PUBLIC COMMENTS ON PRE-APPLICATION DOCUMENTATION, INCLUDING

DESIGN & ACCESS STATEMENT

26TH OCTOBER 2023

Vistry Pre Application Report and Design and Access Statement

Figure 2.8 Page 13 shows the Constraints and Opportunities Plan. Screenshot attached

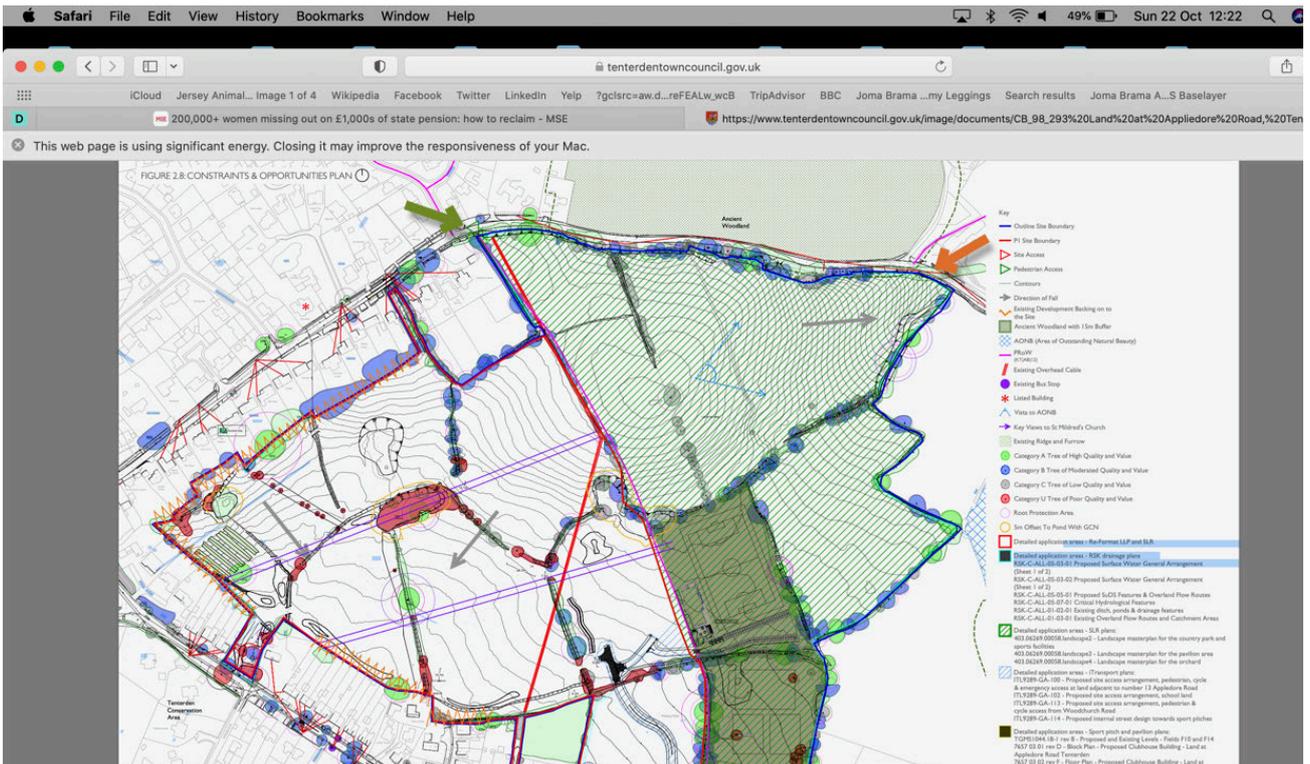
To the north of Rose Cottage there is a area of hedgerow shown red. See Extract. According to the Key this seems to signify Category U Tree of poor quality and condition. This plan fails to identify the Field Maples 309 and 310 which are classed as category B1 in the SJA report. There are also other trees in this hedgerow which are not recorded and also the Field Maple referred to as part of my previous email. This plan is inaccurate and misleading. This is where the road is proposed and it is clear that the developer has taken this information from previous reports which are now distorting the facts. This should be challenged.

A second point is the area to the east of Rose Cottage which shows a grey shaded area which according to the key relates to Category C Trees of Low quality and value. One of these trees is a substantial Oak tree 307 on which should be assessed I believe as Category B1. This is shown on The 2019 Tree Protection Plan by SJA Trees attached and listed on the Arboricultural Implications Report page 83. See attached extract. The drainage from the site is via a culvert to the east of Rose Cottage and any new system installed will require significant digging in the root protection area of this tree. Again the categorisation of this tree should be challenged. There are other B1 Trees in this area although one was a faller in the strong winds a few years ago. This whole group of trees should be reassessed.

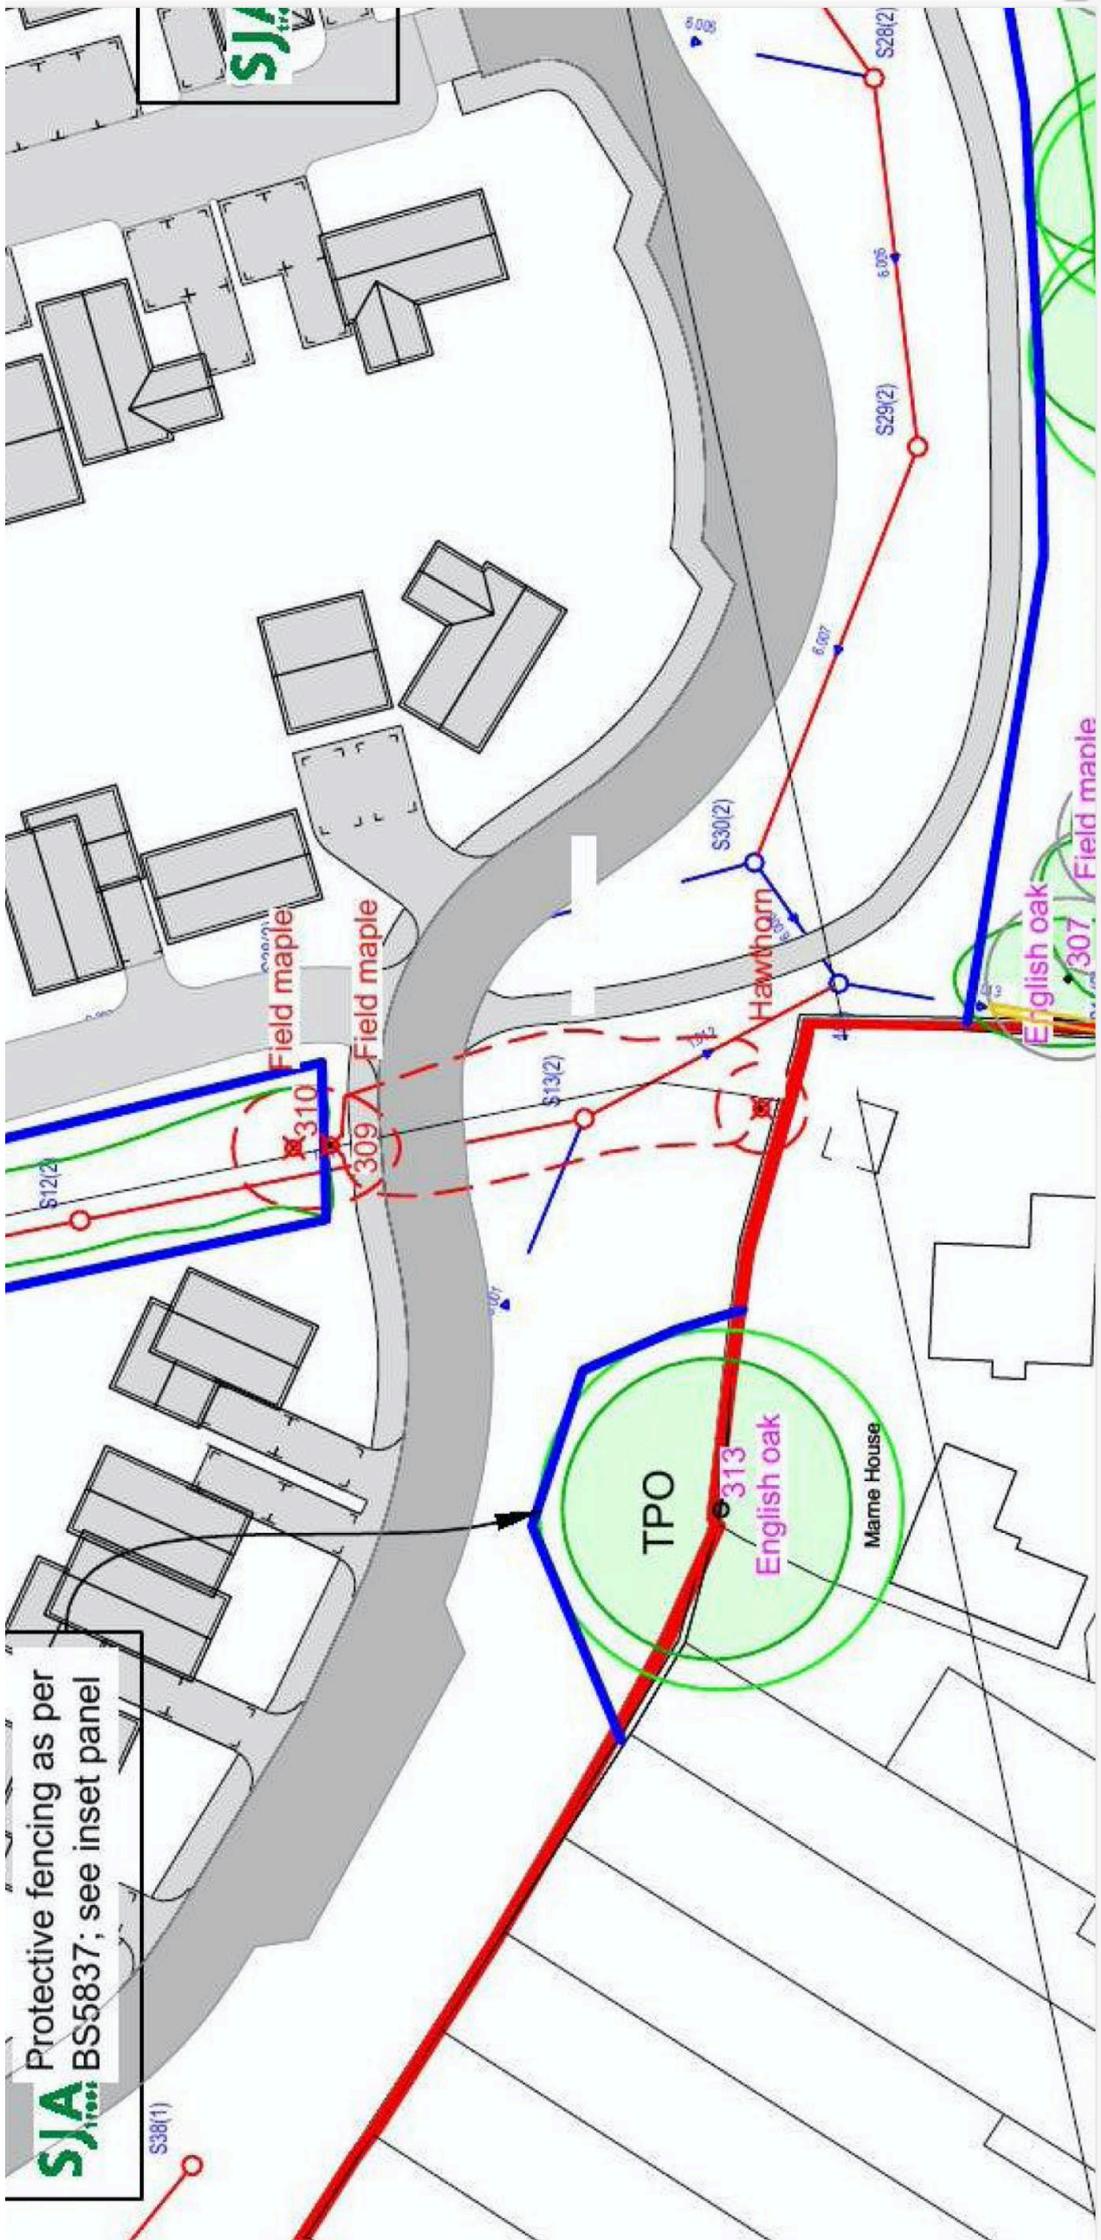
- (2) There is a Protected Oak Tree 313 in the Garden of Marne House which has been underestimated in terms of Root Protection Area and was subject to a 20% offset to the North when Marne House was built. (See Arboricultural Report and extract from Planning Report Appended). This tree throws long shadows across Limes Land and will shade the nearest proposed properties. See photo library. It is illogical to propose new dwellings in the shade of existing trees. The design should reflect the existing environment and not be guided by as yet unbuilt dwellings.

- (3) The current outline application which is being appealed proposes a main access road close to the boundaries of Rose Cottage and Marne House . As a result a 30 metre section of the ancient hedgerow from the boundary fence of Rose Cottage to the north will be destroyed. This includes 2 mature field maples. 309 and 310. See extract Tree Protection Plan and images of Hedgerow in Photo Library. Bats are often seen in this hedgerow. This hedgerow is also a watercourse from which surface water leaves the site via a culvert which reaches Appledore Road and South to Tilden Gill
